# Texas HERO – Final Position Paper

**Date:** April 22, 2005

**Re:** Discussion regarding the technical merits of the 2006 ENERGY STAR EPA proposal and the future of ENERGY STAR in Texas and across the country.

**Table 3 -- Life Cycle Energy Cost Savings for Upgrade from R-4.2 to R-8 Duct**

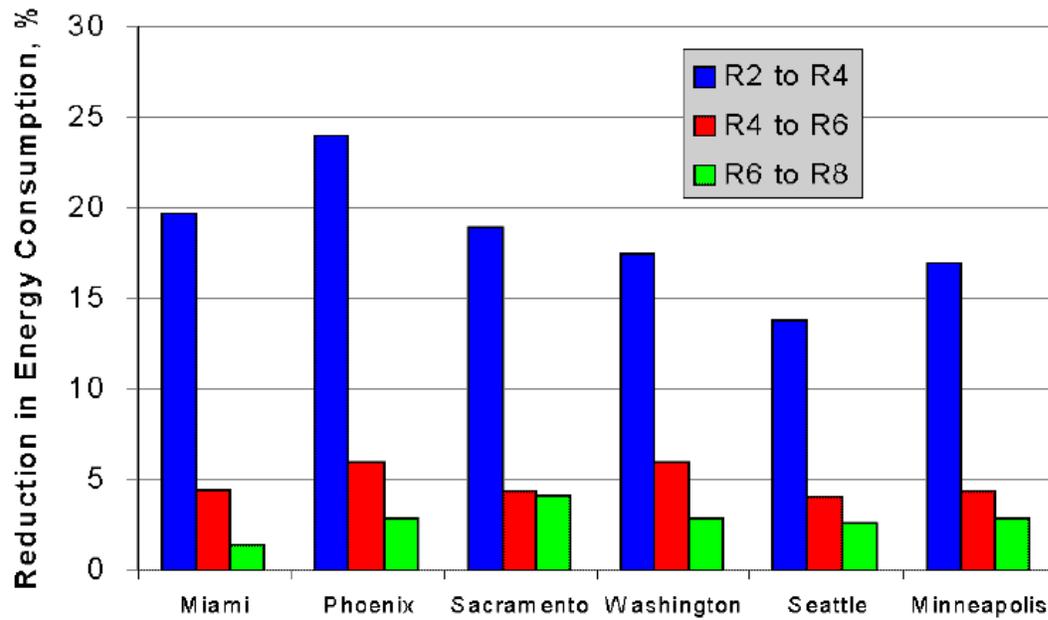
Based on their extensive research and cost analysis, it was determined that installing R-8 duct insulation was only cost effective and beneficial in Climate Zones 14, 15 and 16 which are the Northern Climates. (See table below)
